Access Compliance Report

Public Rights-of-Way

(Curb Ramps)

Intersection ID: N/A	Main Street: REMOUNT_RD	Cross Street: REMUS_RD	Location: S
ADA ID: C081ABF594C8	Ramp Type: Perp	Initial Pass/Fail: Fail	Overall Compliance: No
Codes/Mitigation Info/Possible Solution		Field Measurements/Component Compliance	
Severity Score: 21.25

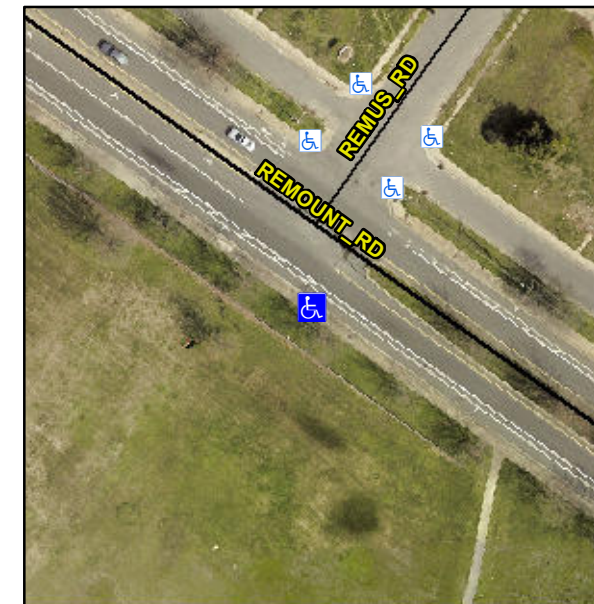
Not Found, R304.5.1, R304.2.2

Compliance	Description	Data	Compliance	Description	Data
N/A	Ramp Length (in)	60.0	No	Ramp Slope (%)	8.6
No	Ramp Width (in)	46.5	Yes	Ramp XSlope (%)	0.1
N/A	Flare Type LT	N/A	N/A	Flare Type RT	N/A
N/A	Flare Slope LT (%)	N/A	N/A	Flare Slope RT (%)	N/A
N/A	Flare Traversable LT?	N/A	N/A	Flare Traversable RT?	N/A
N/A	Landing Length (in)	N/A	N/A	DWS Provided?	N/A
N/A	Landing Width (in)	N/A	N/A	DWS Contrast?	N/A
N/A	Landing Slope (%)	N/A	N/A	DWS Length (in)	N/A
N/A	Landing X Slope (%)	N/A	N/A	DWS Full Width?	N/A
N/A	Landing Curb? (Y/N)	N/A	N/A	DWS Offset (in)	N/A
N/A	Shared Landing?	N/A			
N/A	Gutter Ponding?	N/A	N/A	Gutter Slope (%)	N/A
N/A	Gutter Lip Ht (in)	N/A	N/A	Gutter X Slope (%)	N/A
N/A	Painted X Walk1?	No	N/A	Painted X Walk2?	N/A
	X Walk 1 Direction	To NE		X Walk 2 Direction	N/A
N/A	X Walk 1 Width (in)	N/A	N/A	X Walk 2 Width (in)	N/A
	X Walk 1 Slope (%)	2.6		X Walk 2 Slope (%)	N/A
	X Walk 1 X Slope (%)	0.2		X Walk 2 X Slope (%)	N/A

Remove & Replace Entire Ramp.
